Office Action Summary

10/652,110

BUCUR ET AL.

DETAILED ACTION

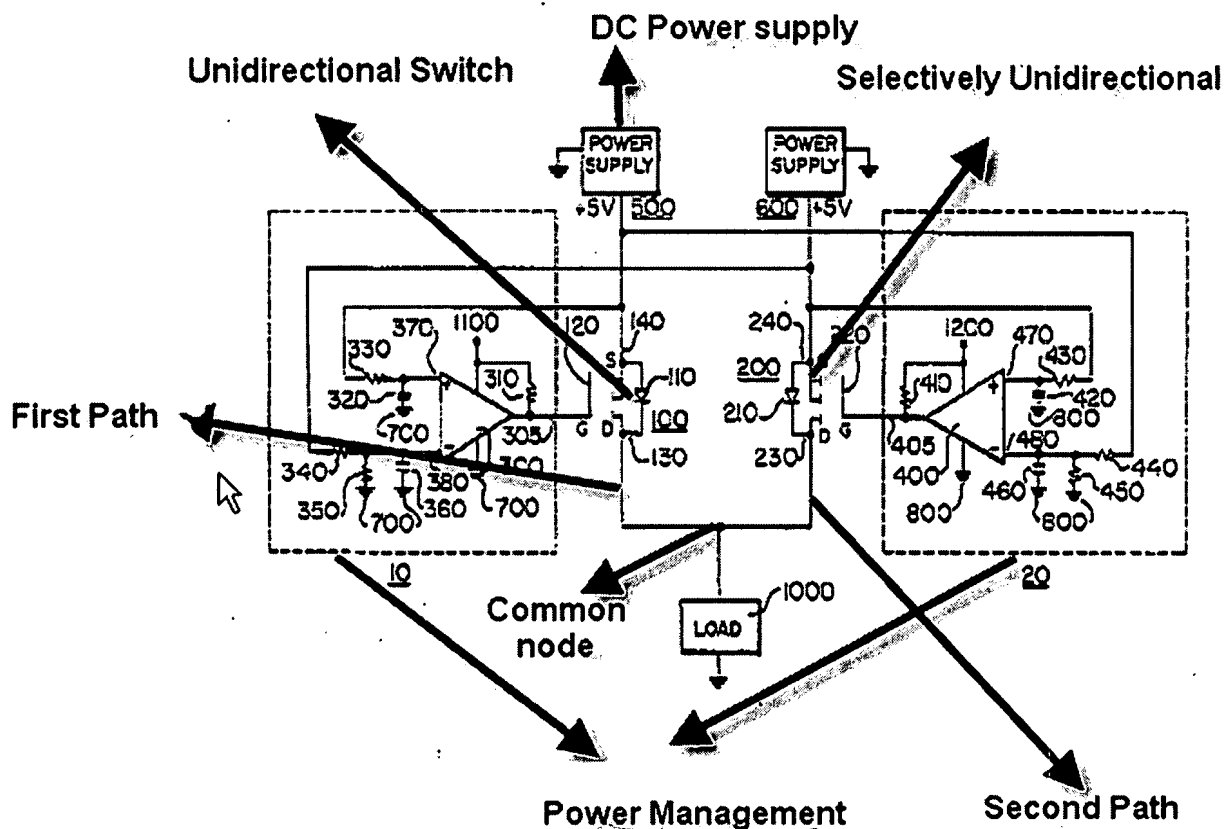
Regarding Claim 1, Cowan et. al. discloses in Figures 1-3, a power supply topology comprising:

A first path (see figure above) configured to be coupled to a controllable DC power source (C1); a second path (see figure above) configured to be coupled to a rechargeable battery (B1); a third path (see figured above) configured to be coupled to a system load (see figure 4), wherein said first, second, and third paths are coupled to a common node; a unidirectional switch (140) coupled to said first path to allow selective coupling of said controllable DC power source to said system load via said common node; and a selectively unidirectional switch (240) coupled to said second path to allow selective coupling of said battery to said common node; a power management control circuit (10 and 20)n configured to control the conduction state of said unidirectional switch (see figure above, 110) to a closed position to enable said controllable DC power source to supply power to said system load via said common node (see figure above) , said power management control circuit is further configured to control the conduction state of said selectively unidirectional switch (see figure above, element 220) to a first closed position to enable said rechargeable battery to supply power to said system load via said common node and to prevent a current flow from said controllable DC power source to said rechargeable battery (noted that the diodes that are presented with the switches are served to protect any reverse currents going into the power supplies) ; wherein when said unidirectional switch is in said closed position and said selectively unidirectional switch is in said first closed position, said controllable DC power source and said rechargeable battery are coupled in parallel (See column 1, lines 50-54, Claims 6 and 11)
